APPLICATION NO.	FILING DATE	FIRST NAMED INVENTOR	ATTORNEY DOCKET NO.	CONFIRMATION NO.
09/941,934	08/30/2001	Joe Cargnelli	9351-072	6332

Office Action Summary	Application No. 09/941,934	Applicant(s) CARGNELLI ET AL.	
	Examiner Tho v Duong	Art Unit 3743

DETAILED ACTION

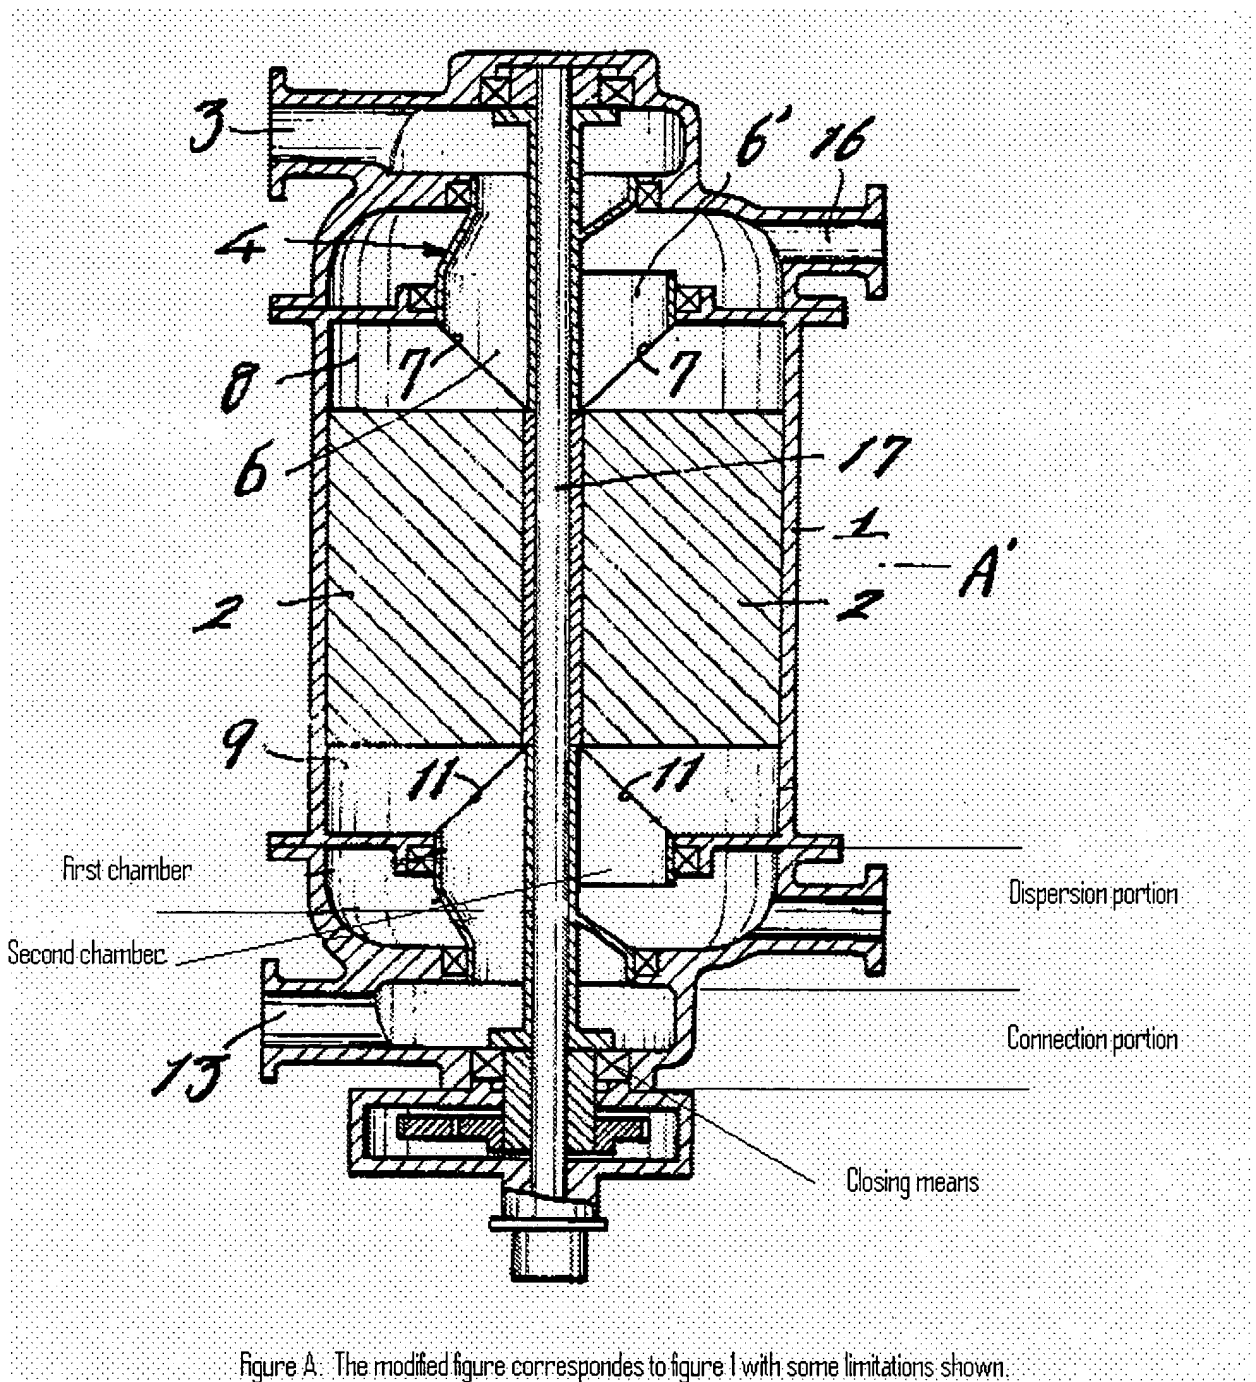
Claims 1-3,5,9,11-14,17-18,27,29-33,35-40 and 42 are rejected under 35 U.S.C. 102(b) as being anticipated by Nakajima Seiki (DE 2512065A). Nakajima discloses (figures 1-4 and A) a regenerative energy exchange assembly comprising an exchange media having a casing (101); a first chamber and a second chamber (6,6') having a first, a second fluid channels (12,15) adjacent the exchange media to pass a first fluid stream and a second fluid stream through the exchange media respectively; the first and second chambers separated by a divider; at least one fluid stream diverter (4) being rotatable orientation and providing separate flow communications (13,14) to the chambers through the respective fluid channels; the fluid stream diverter having a radial extent that is less than the functional radial extent of the exchange media, wherein, at any given diverter orientation, the separate flow communications (103,116) are not in fluid communication with the same chamber; a housing (manifold) connected to one end of the exchange media (1) and wherein the fluid channels are provided in the manifold; the manifold has interior walls defining an inner enclosure, and the fluid stream diverter is provided in the inner enclosure; the fluid stream diverter is rotatably mounted within the inner enclosure to provide the diverter within the adjustable orientation; a shaft (17,117) extends rotatably through the exchange media, and the housing (manifold), wherein the fluid stream diverter (4) is fixed to the shaft; the housing (manifold) comprises a connection portion and a dispersion portion which are in fluid communication with each other; the dispersion portion has an open end that is in fluid communication with the exchange media; the connection portion has one port (13) in flow communication with the respect fluid channel and has a radial extent that is less than the radial

extent of the dispersion portion; the dispersion portion comprises the first and the second chambers. Nakajima further discloses (figure 2) the exchange media is housed in a plurality of media cavities (2) that are separated from one another in cross section and extent in parallel along the exchange media; the plurality of media cavities are positioned in correspondence to the chambers of the dispersion portion; the plurality of cavities are disposed within the casing (1); the connection portion has an open end and a closing means (bearing) which closes the open end. Nakajima discloses (figure 1) the assembly has a first end housing and a second end housing disposed on either end of the exchange media; a first fluid stream diverter (4) is disposed within the end housing and a second fluid stream diverter (10) is disposed within the second end housing; the first and second fluid stream diverters are disposed correspondingly in the respective end housings and rotate by shaft (17) in phase during operation. Nakajima further discloses that the first fluid stream and the second fluid stream are in opposite direction.
